IDEA PUBLIC SCHOOLS – Mid Valley Building Envelope

ADDENDUM NO. 3

(ATTACHED: RFI from Argio Roofing with GMS Response. Responses included in the following addendum). Total Sheets = 23

01 ROOF PLAN
SCALE: 3/32" = 1'-0"

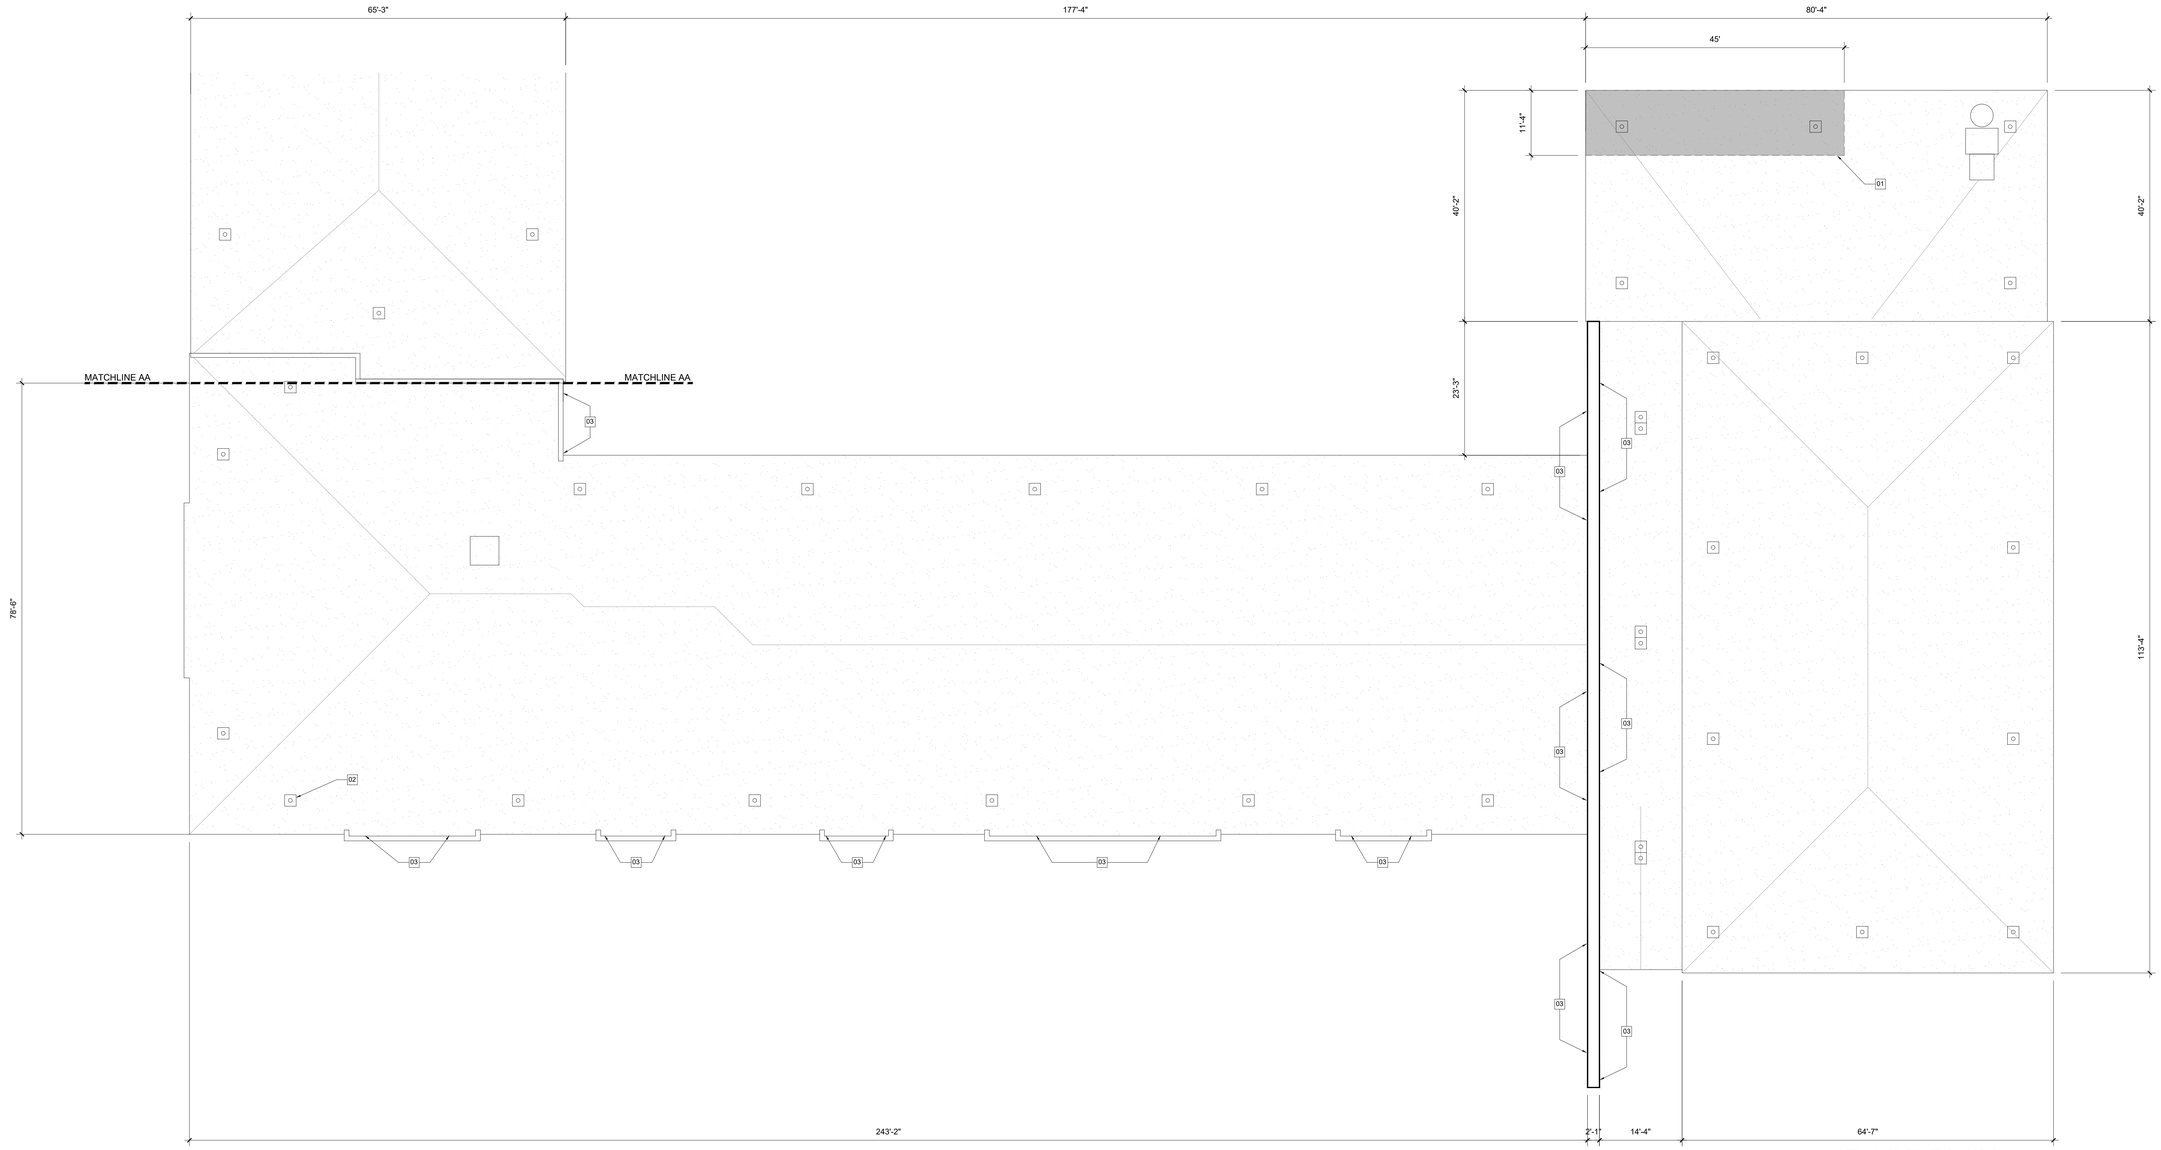
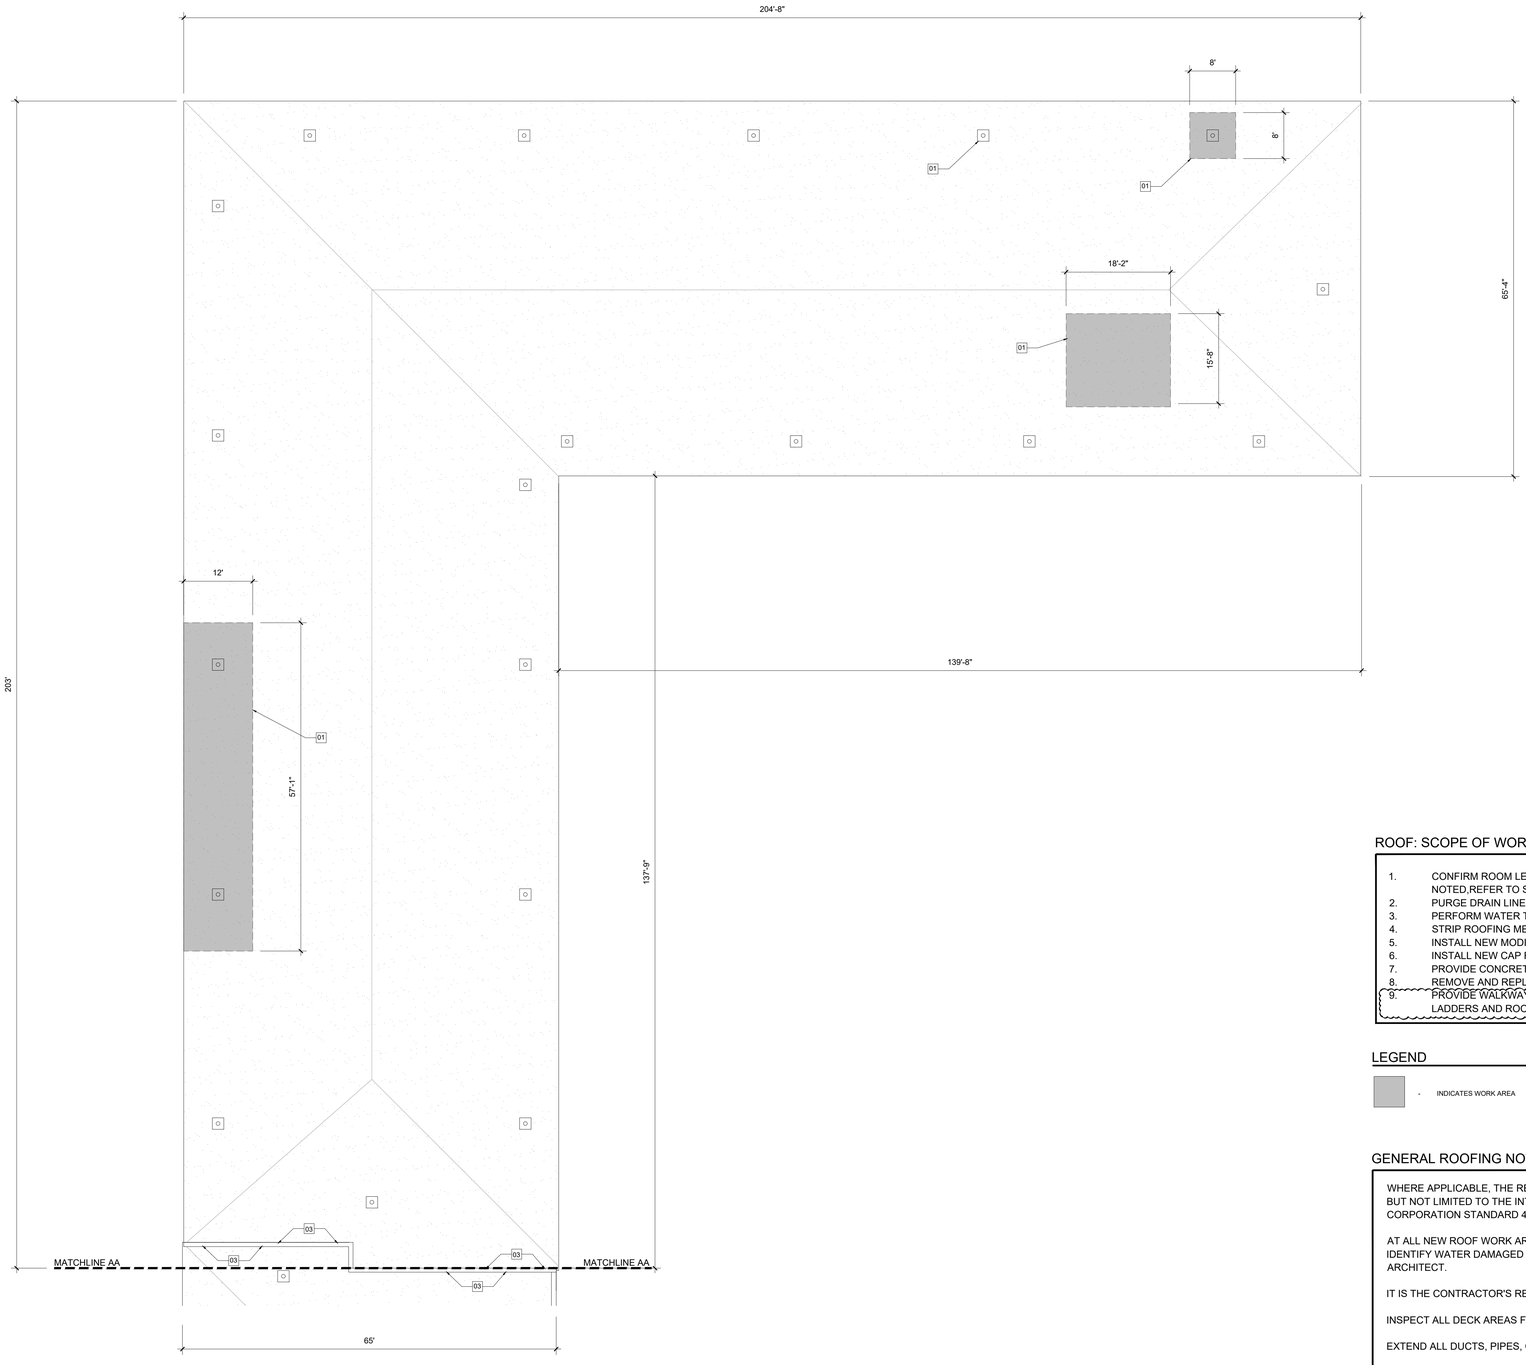
- Shaded areas are the only areas that exhibited leaks upon initial inspection. However, we anticipate other areas may have leaks once roof drains are water tested as required which shall be addressed utilizing contingency budget and submitted unit price for related work.
- When demolition of roof is required, remove existing roof material down to deck. Notes clarified on sheets A2.01, A2.02
- Replace roof fasteners only, only add wall fasteners when fasteners are missing, and holes exposed.
- Roof tiles damaged during testing shall be replaced as required, refer to updated general note.
- Clarification: Provide walkway system to and around mechanical equipment roof hatches and roof access ladders on roof. Refer to A2.01-A2.02 scope notes.

1. Are the shaded areas on the roof the only areas to be worked on?
2. Page A2.0 Keyed Note 01, states to provide new tapered insulation and Roof: Scope note #4 states to strip the membrane to cover board. Can you clarify? Strip to deck, note clarified
3. The replacement of fastenrs is on the inside part of the parapet wall only, not the outside face of the wall panels? Only at roof, however, if wall fasteners are missing and holes exposed, provide as required.
4. Testing the roof drains may require removing some ceiling tiles, do we consider replacing tiles at all or will that be done by owner.

1. CONFIRM ROOM LEAK LOCATIONS AND REPLACE ROOFING IN AFFECTED AREAS AS NOTED,REFER TO SHEET A3.01 FOR DETAILS
2. PURGE DRAIN LINES FROM ROOF LEVEL TO DISCHARGE POINTS.
3. PERFORM WATER TEST AT ALL ROOF DRAINS.
4. STRIP ROOFING MEMBRANE TO DECK. 03
5. INSTALL NEW MODIFIED BITUMEN ROOFING SYSTEM.
6. INSTALL NEW CAP FASCIA AND ACCESSORIES.
7. PROVIDE CONCRETE SPLASH BLOCK AT EXTERIOR DOWNSPOUTS.
8. REMOVE AND REPLACE FASTENERS AT ROOF WITH ONE SIZE LARGER THAN INSTALLED. 03
9. PROVIDE WALKWAY SYSTEM TO AND AROUND MECHANICAL EQUIPMENT, ROOF ACCESS LADDERS AND ROOF HATCHES ON ROOF.
